## LAKE NONA LANDING RETAIL

<p><b>Owner</b> Scott Peek Narcoossee Land Holding Two, LLC</p> <p><b>Applicant</b> Heather Isaacs Tavistock Development Co.</p> <p><b>Project Planner</b> Colandra Jones, AICP</p>	<p><b>Property Location:</b> The subject property is located west of Andric Lane, south of Tagore Place, and north of Vickrey Place (±18.01 acres, District 1).</p> <p><b>Applicant's Request:</b></p> <ol style="list-style-type: none"> <li>1. Specific Parcel Master Plan (SPMP) approval for 121,100 square foot big box retail with a 37,200 square foot garden center on ±12.76 acres within the Education Village PD.</li> <li>2. Request to redistribute land uses within the Education Village PD.</li> <li>3. Request for Major Subdivision Plat to create the Preliminary Plat for retail development.</li> </ol>	<p><b>Staff's Recommendation:</b> Approval subject to the conditions in the staff report.</p>
<p><b>Updated:</b> March 4, 2016</p>

# PROPOSED SITE PLAN

# EDUCATION VILLAGE PD DEVELOPMENT PLAN

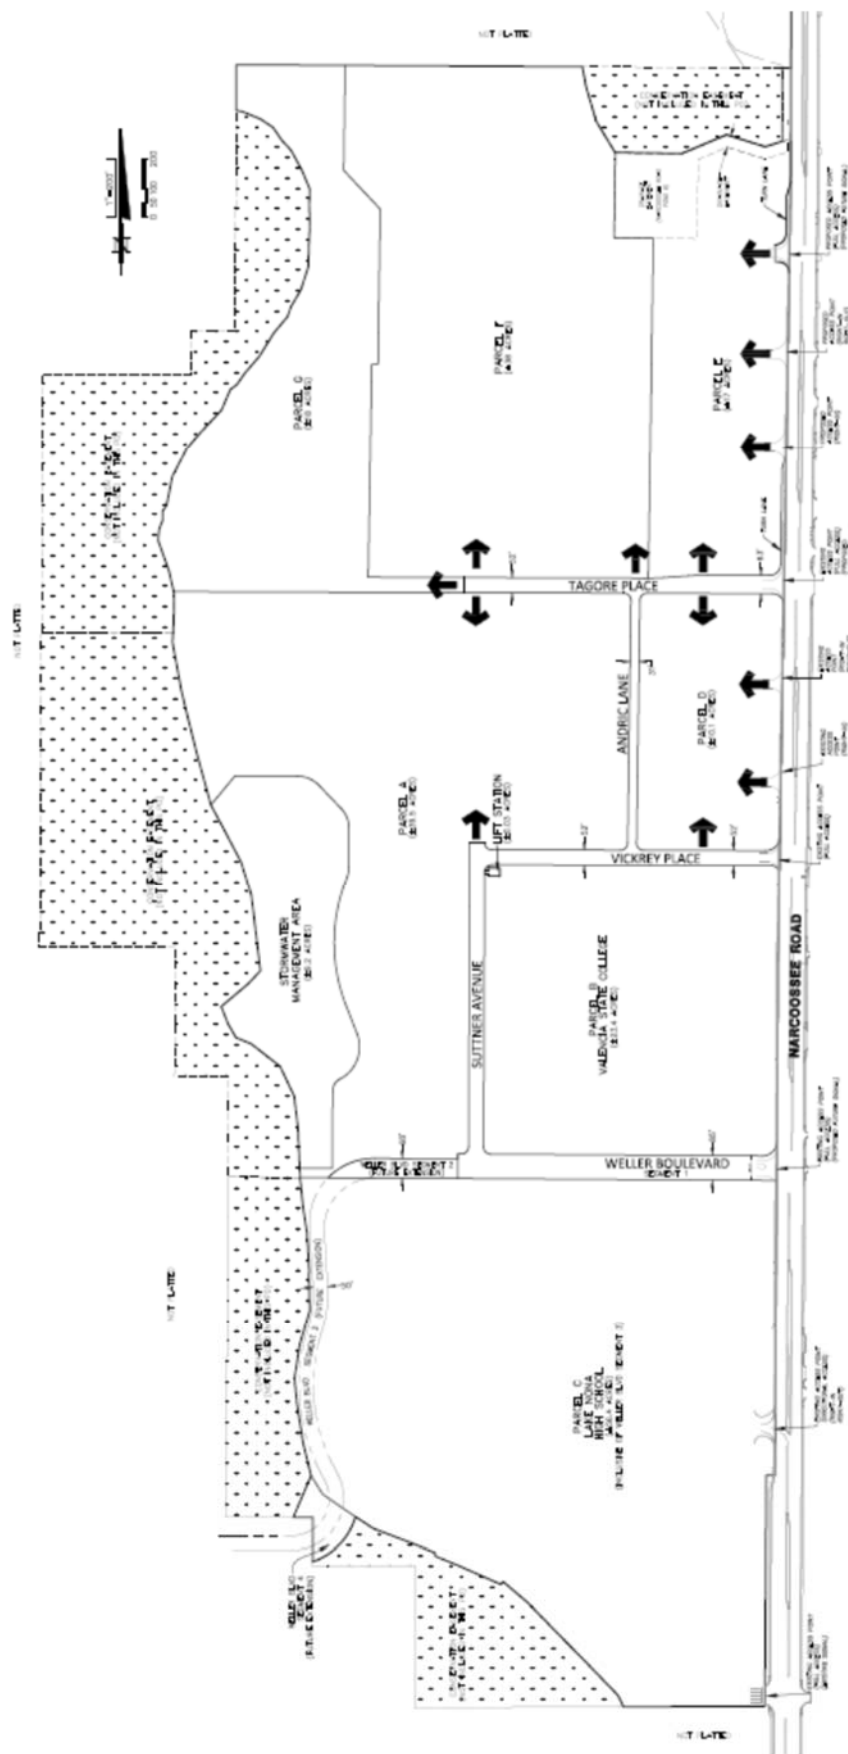
This reconfigured land use plan will result in a residential use (on Parcel G) behind the big box stores (on Parcel F). The plan will also create an unusual shape for the development of multifamily to the south of the subject property (on Parcel A). In order to provide adequate access and circulation for residential uses in these locations, staff may require a north/south connection from Weller Boulevard to Tagore Place as part of a future SPMP application. This could be accomplished using Suttner Avenue, but should not rely on Andric Lane, which is too narrow and would require too many turning movements. The purpose of this connection is to allow residents to travel west toward other portions of Lake Nona without navigating through commercial use areas or out to Narcoossee Road.

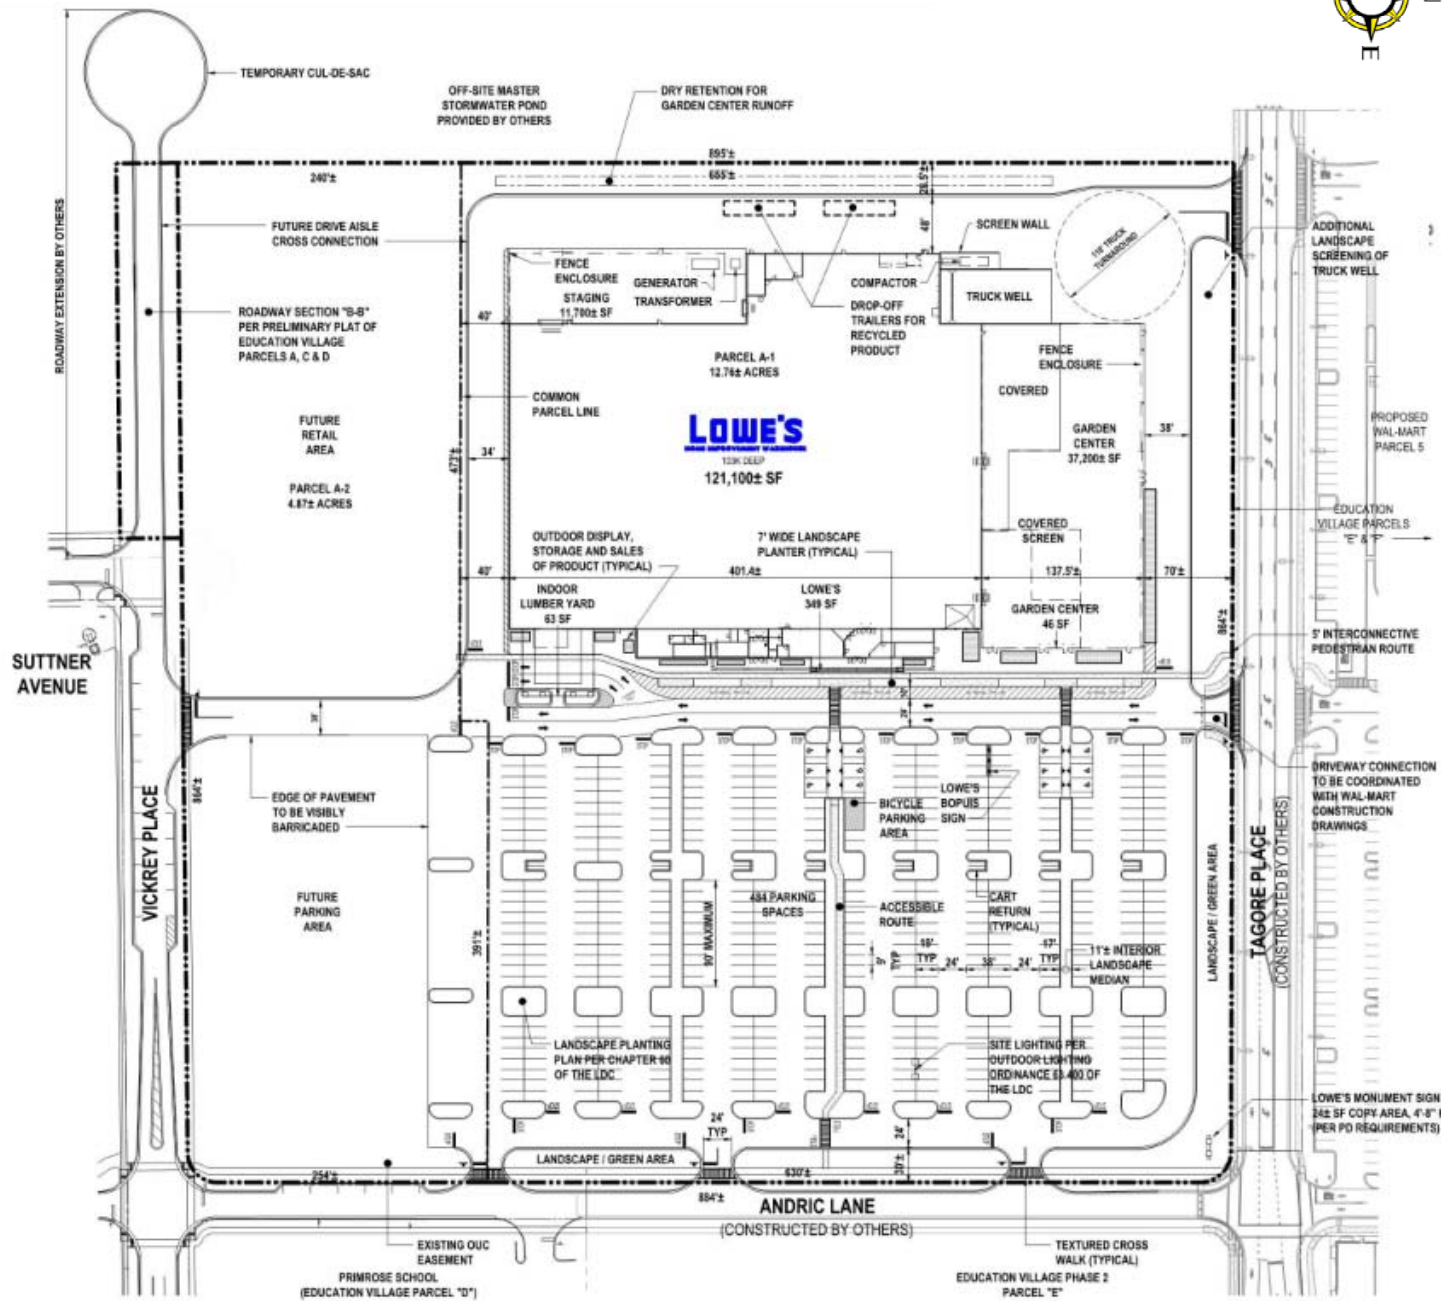
Per City Code Sec 61.333, bike racks shall be installed to provide space for 4 bikes to be secured. The racks shall conform to City standards and be located on an impervious surface so as not to interfere with pedestrian or other vehicular movements. The location shown on the submitted plans is acceptable.

1. The southernmost driveway on Andric Lane is to be removed or relocated to line up with existing driveway to the east. Shift the middle driveway to the north to line up with drive aisle.

3. Southern driveway shall be aligned with Suttner Avenue. Suttner Avenue will eventually extend south to Weller Boulevard and will be the main access point for local traffic to the west that want to avoid Narcoossee Road. The current proposed location would create significant left turn conflicts.

# ARCHITECTURAL ELEVATIONS

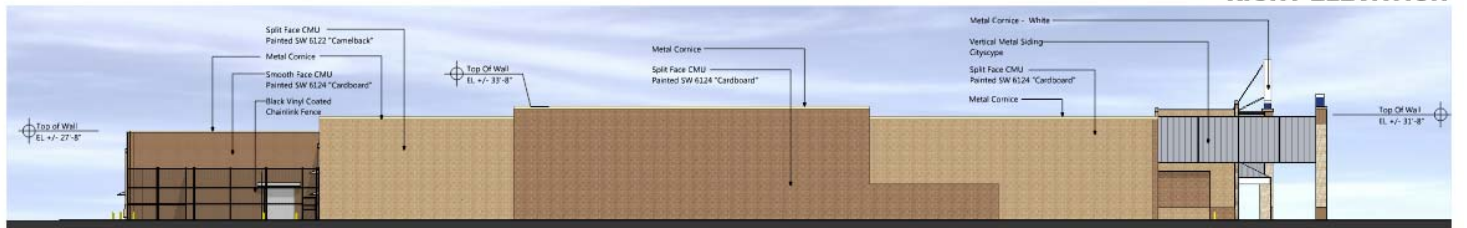
1. A landscape plan was not provided with this application. Landscape will be reviewed during the building permit process.
2. The building elevations are approved as submitted.
3. Proposed signage is approved as submitted, but shall require a separate building permit.
4. All exterior ingress and egress doors shall include a minimum 4"x6" view window.
5. Urban Design reserves the right to review and provide additional conditions during the building permit review process.
